PLANNING & ZONING BOARD MEETING AGENDA

Meeting Name: Planning & Zoning Board
Meeting Date: January 6, 2024
Prepared By: Isabella Hickey/ Stephen Mayer
Item Title: Appearance Review – 451 Neptune Road

Meeting Name: Planning & Zoning Board
Meeting Date: January 6, 2025
Prepared By: Stephen Mayer
Item Title: Appearance Review – 401 Diana Lane

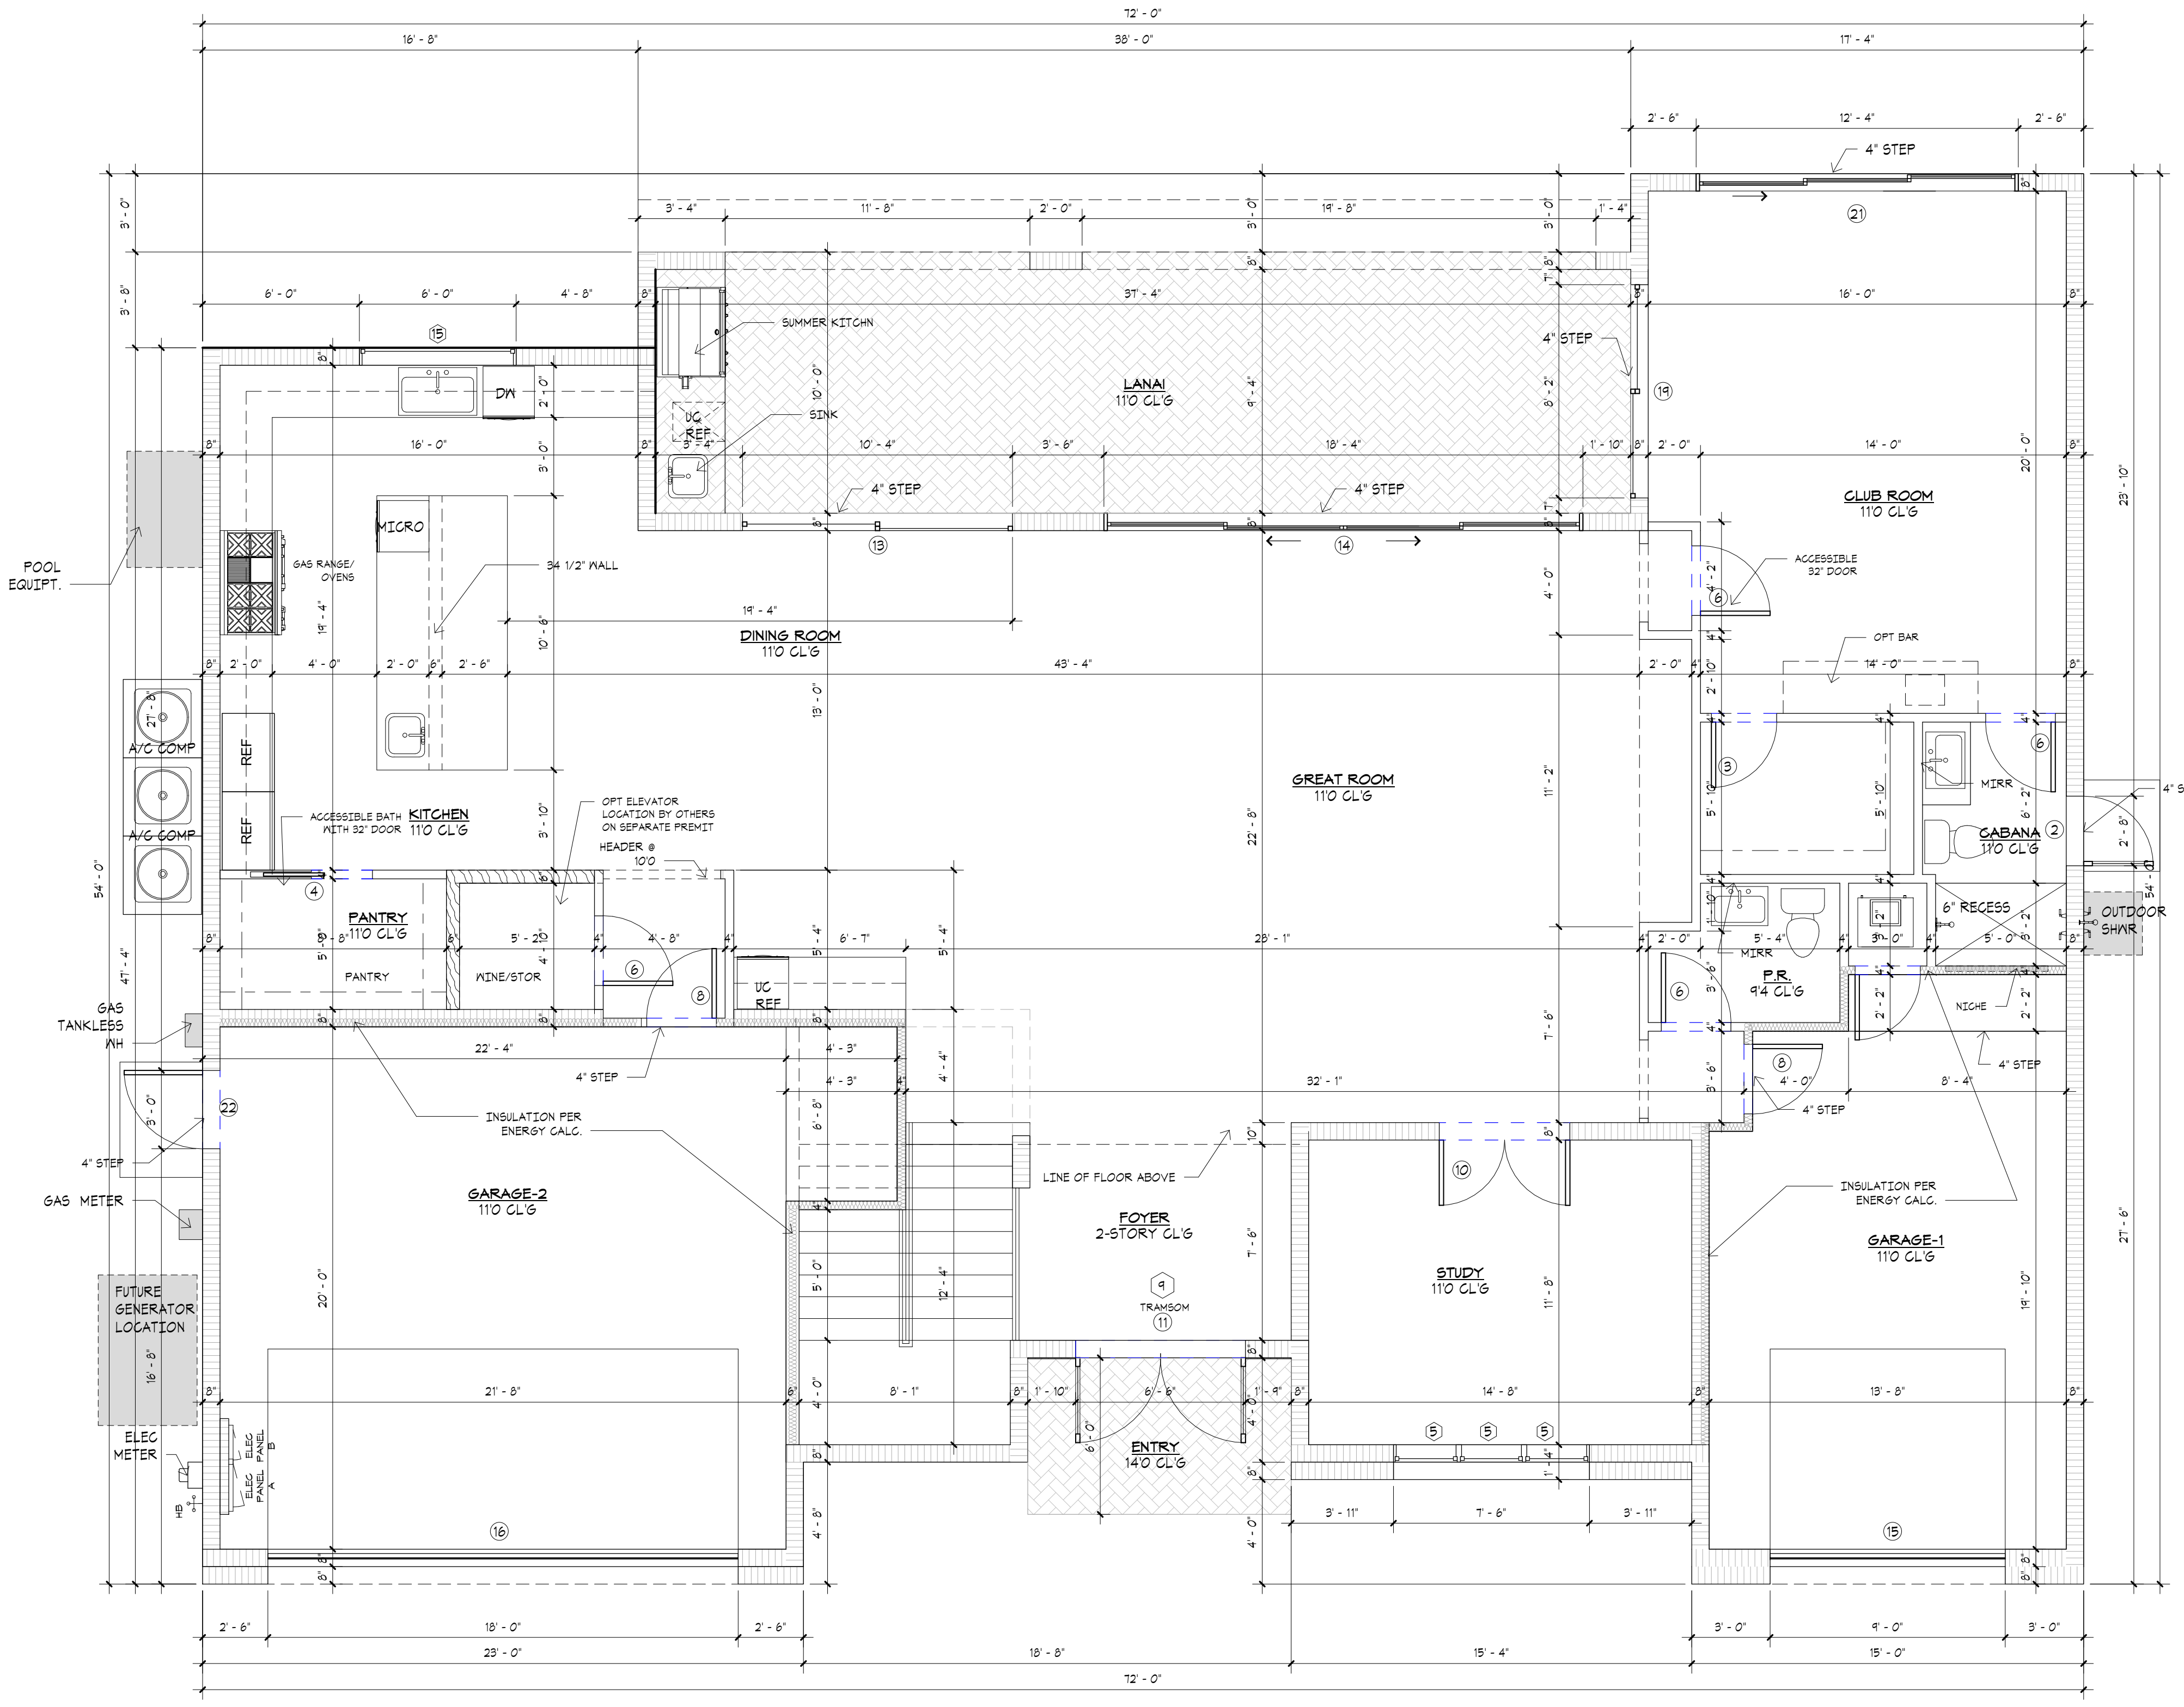
The tower element was measured as only 53 square feet on the plans (please see the area calculations on A-1 and the detail of the tower and accessible terrace on A-2.1). However, the tower element is 9.33' by 17.33' in dimension from outside wall to outside wall and would therefore be 162 square feet. The accessible terrace may only be 63 square feet large (225 SF – 162 SF tower element = 63 SF). Therefore, the proposed accessible terrace area (measured at 167 square feet) is 104 square feet too large and must be reduced on the final plans prior to building permit application.
